SPRINGS LOFTS

RFI#: 37 Date: 1/23/2012 Job: EB-02 Keller Springs Lofts Phone: 877-777-5115

Date Required: 1/25/2012 Request: On sheet P-3.0C the main sanitary trunk line is shown running in the center of the corridors. It is 6" running north along the east side of the garage. It joins another 6" running east along the north side of the garage. So we have a 6" joining with another 6" but there is no designation as to the size of the line after that until it meets the 10" that leaves the building. Sheet P-3.0E gives no designation to the size of this line either. I feel this may be an oversight and the intention would be to have the large to an 8" after the (2) 6" lines merge. Please advice and respond as we are going to be installing these lines in the next two days.

P-9.1

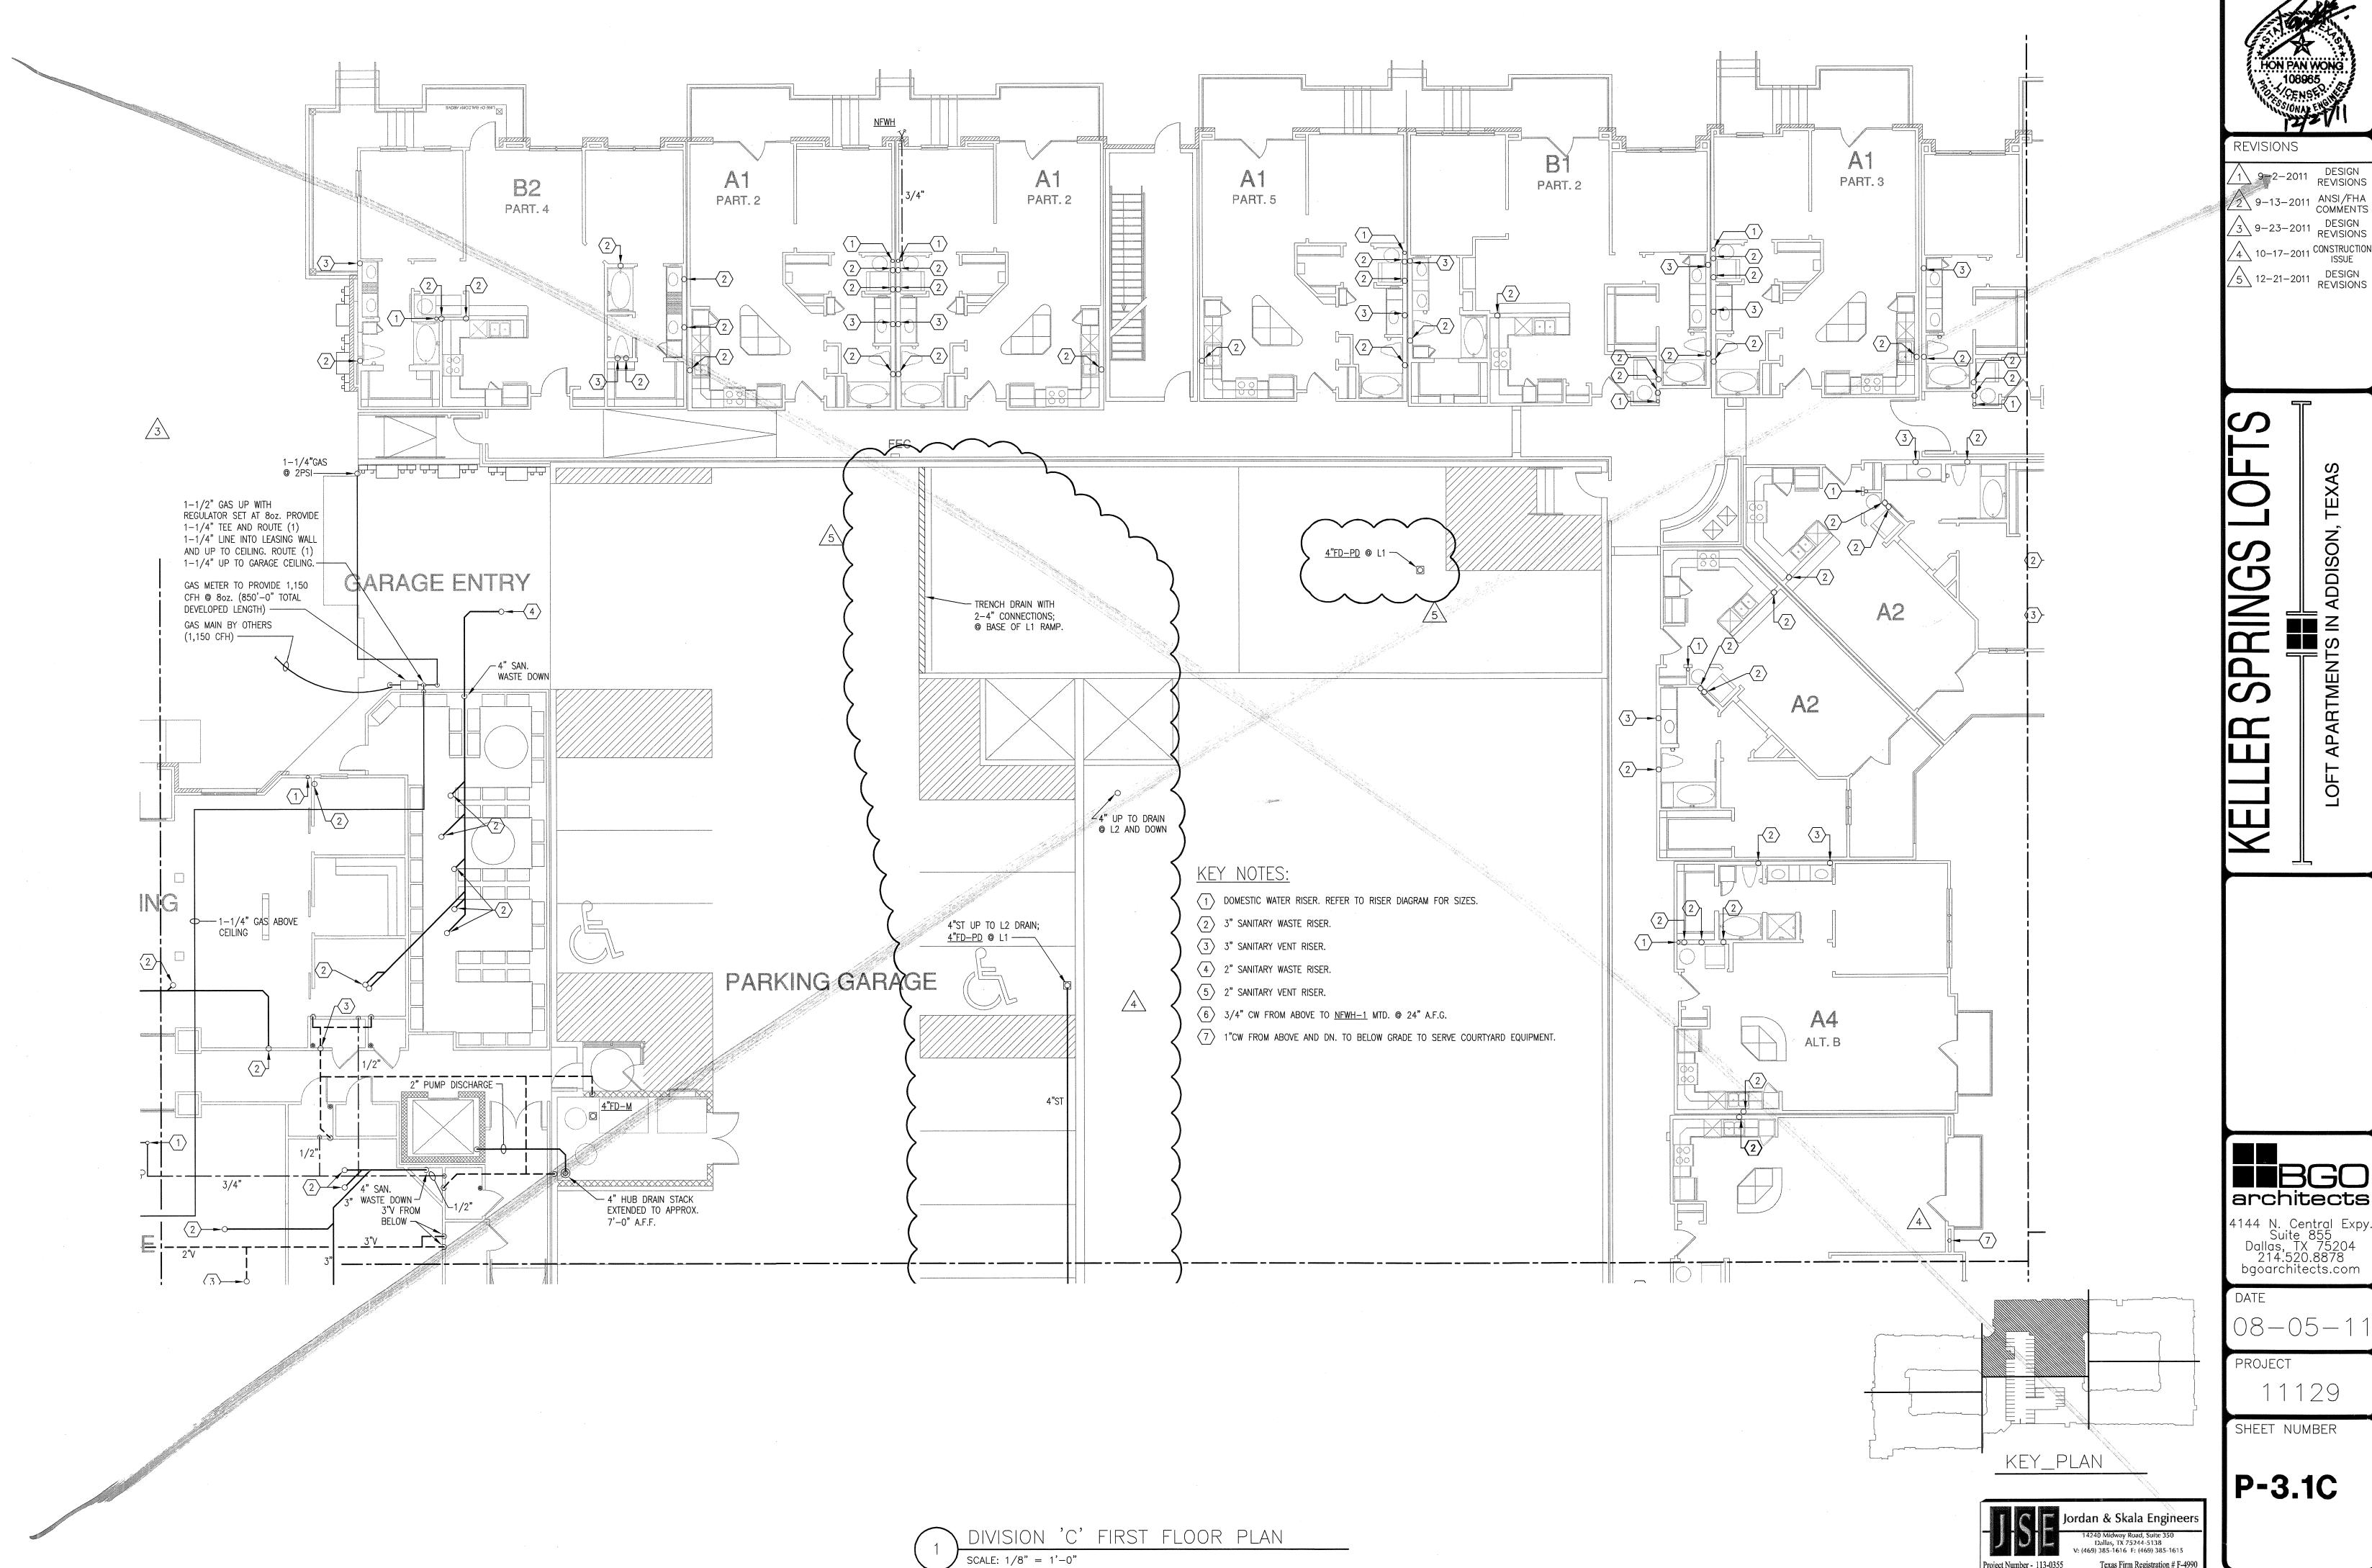
Architectural 4/6.4 show inside dimensions for the Pump Room as 24'-8" X 17'-10", sheet 3.1D and P3.1D scale out the same using the 1/8" scale. Going to P-9.1 (which my plumber did) and using the ½" scale that is called out, the room scales to 21'-9" X 15'-6". The detail and sheet needs to be revised to scale to the correct dimensions which are 24'-8" X17'-10" this error has already created problems with my plumber who had to move his plumbing underground after using the detail on P-9.1. Requested by: Bryan Pickler Embrey Partners, Ltd. See attached sheet P-9.1 for corrected plan scale.
